Agenda – Council – March 21, 2019

Item No. 1 Subdivision and Rezoning – 1415 Regent Avenue West (Transcona Ward) File DASZ 21/2018 [c/r DAV 154739/2018D]

Title: DASZ 21/2018 – 1415 Regent Ave W

Issue: Proposed Plan of Survey and Rezoning to Increase the Size of a Leasehold Estate to Encompass a Proposed Hotel Expansion

SCHEDULE "A" OF FILE DASZ 21/2018, East Kildonan – Transcona Community Committee, dated January 28, 2019

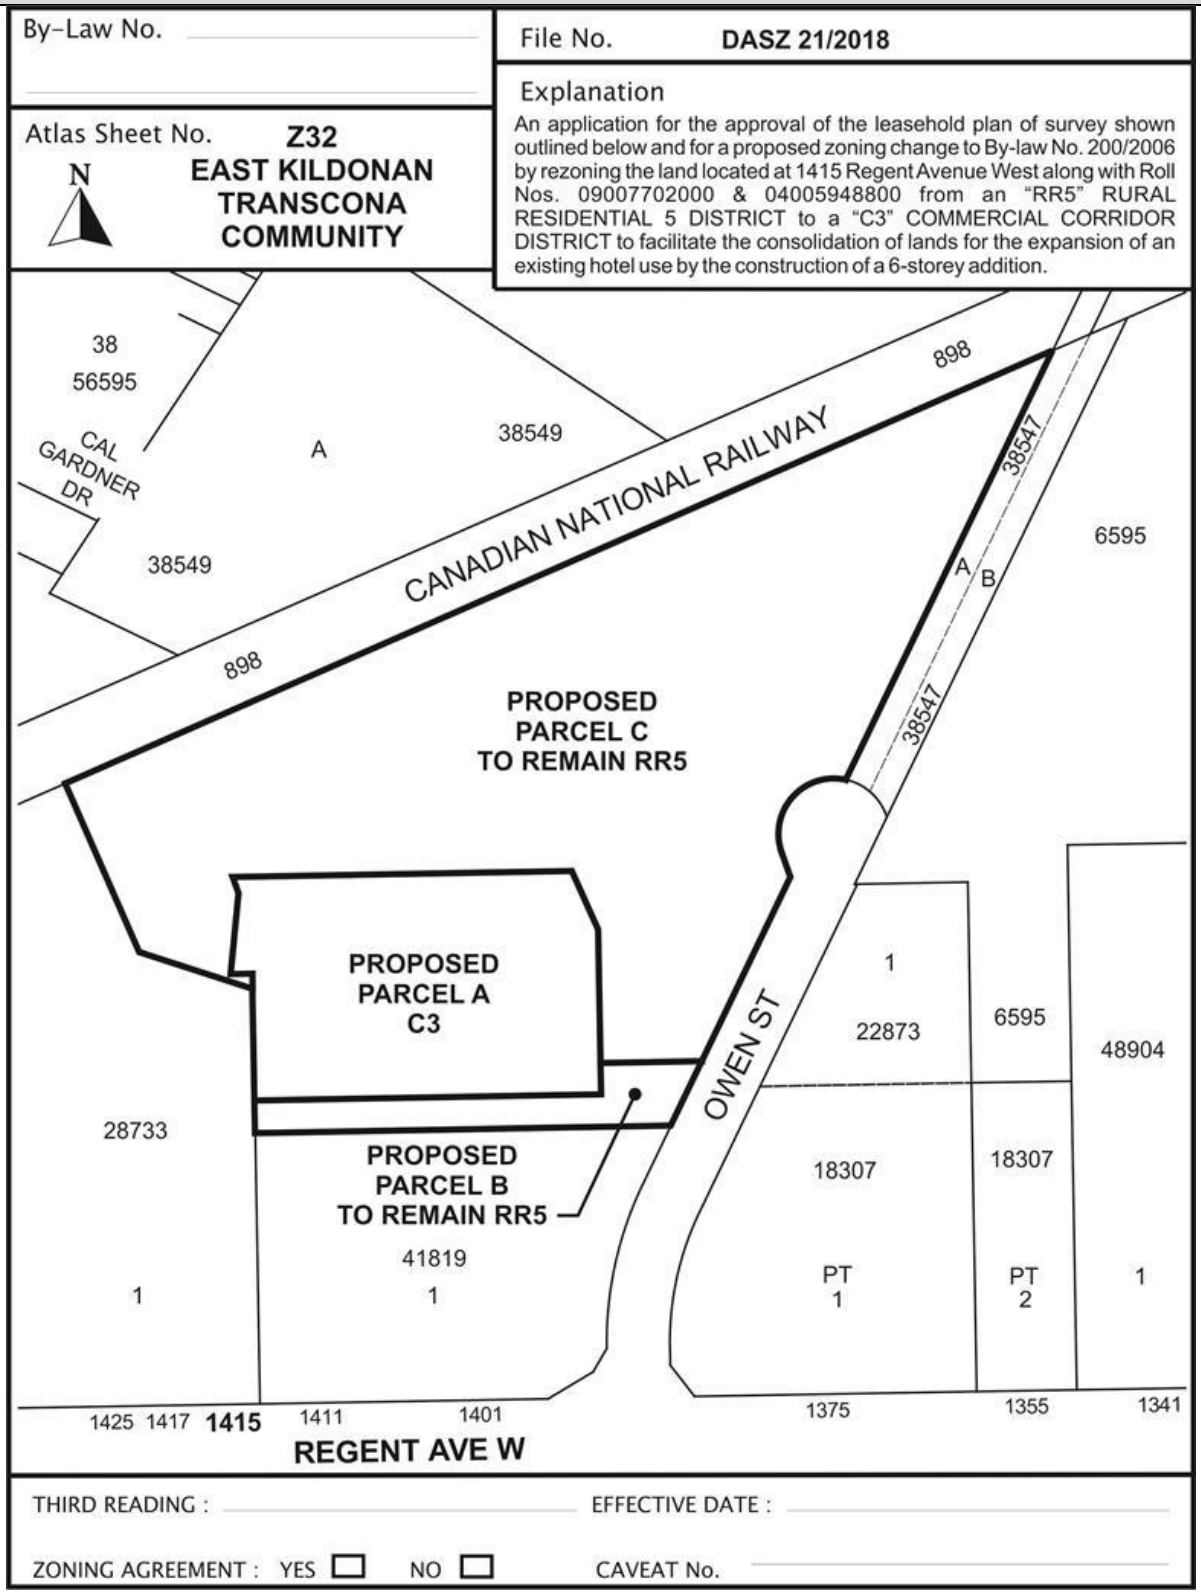
The proposed plan of survey, shown on Schedule "A," would reconfigure the site into three parcels:

- Proposed Parcel A would be larger than the existing parcel that encompasses the hotel; and
- Proposed Parcel A would encompass the hotel (as it exists and after it is expanded), accessory parking, landscaping and walkways.

The proposed rezoning, shown on Schedule "A," would rezone part of the site from "RR5" to "C3" such that proposed Parcel A would be entirely in a "C3" District.

LAYOUT & MATERIALS PLAN

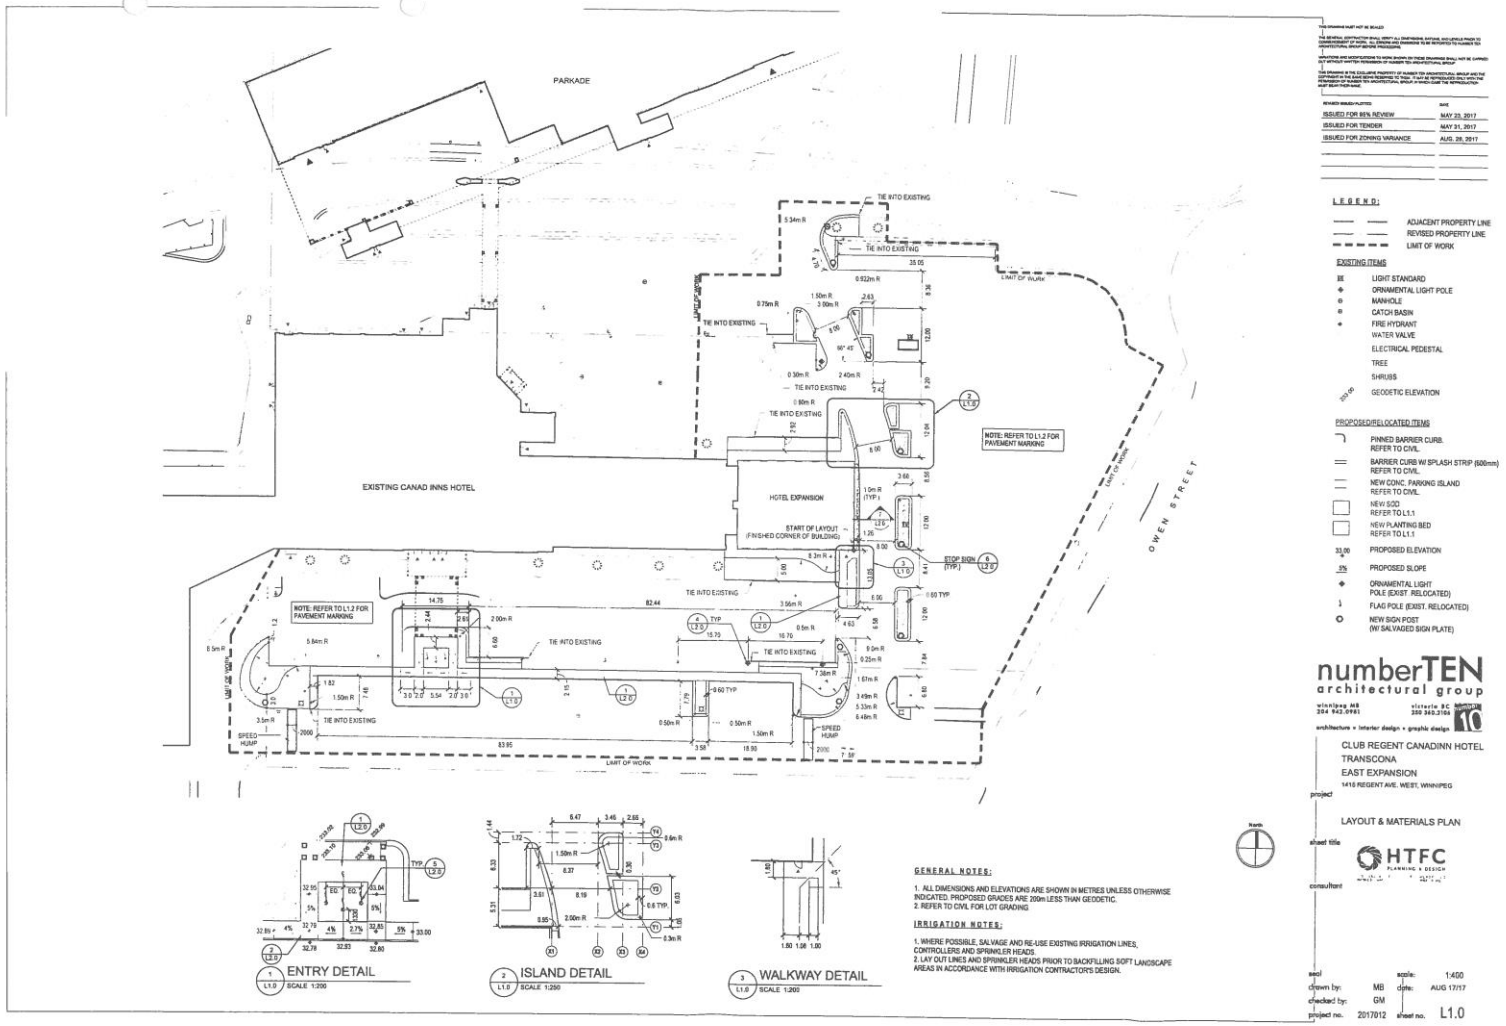
Plans of the proposed development show that a walkway from the hotel to one of these future sidewalks or paths, is not proposed. (The Analysis and Issues section, below, explains why this omission is relevant.)

it should be modified to include a walkway from the front of the hotel to a future sidewalk or path to be built from Regent Avenue West, north to the roundabout in Owen Street.

This modification must be made before final plans are submitted for approval by the Director of Planning, Property and Development and the East Kildonan – Transcona Community Committee.

This section reinforces that the proposed development requires modification to include a walkway from the hotel to a future sidewalk or path to be built from Regent Avenue West, north to the roundabout in Owen Street.
